Annex 5: Customer declaration HW change description v1.2 to Test Report 20-1-0017101T04a-C1

1 LOCU1xxx HW change description v1.2

Hardware change description
SICK LOCU1xx – UWB TAG

v1r3 -> v1r3.1 change description

Details for changes of LOCU Battery Basic/Advanced bottom layer:

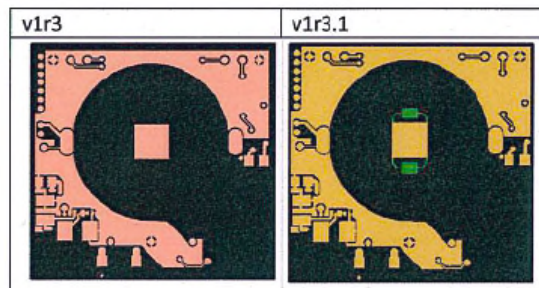
1. Battery holder: Pad adjustment of negative battery contact- milled grooves for battery holder are shifted in v1r3.1 comparing to v1r3. The pitch of grooves is increased by 0,45 mm.

- red mark - v1r3
- green mark - v1r3.1
